TELEPHONE SETS—851- AND 2851-TYPE

1.001 This addendum supplements Section 503-601-101, Issue 7. Place this pink sheet ahead of the section.

1.002 This addendum is issued to:

Fig. 29—2851CM Telephone Set, Connections (Sheet 2 of 2)

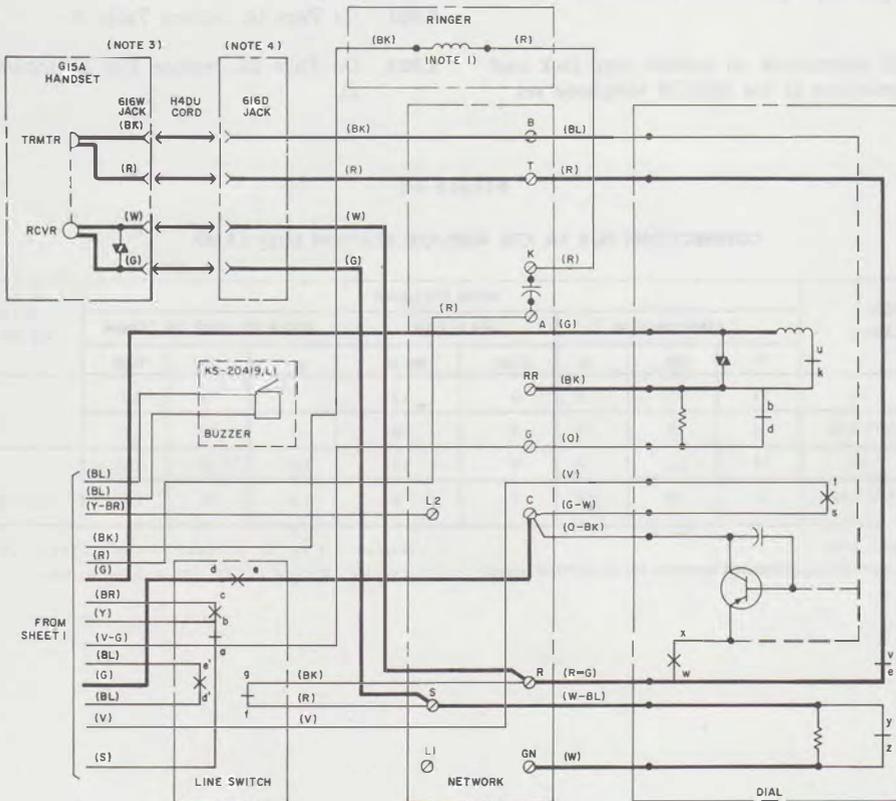
- (a) Add information on the D-180864 Kit of Parts for use with Station Busy Lamp Option feature.
- (b) Delete KS-15724L1 diode for use with Station Busy Lamp Option feature.
- (c) Add information on handset cord jack lead connections in the 2851CM telephone set.

2.003 On Page 25, replace Fig. 29 (Sheet 2 of 2).
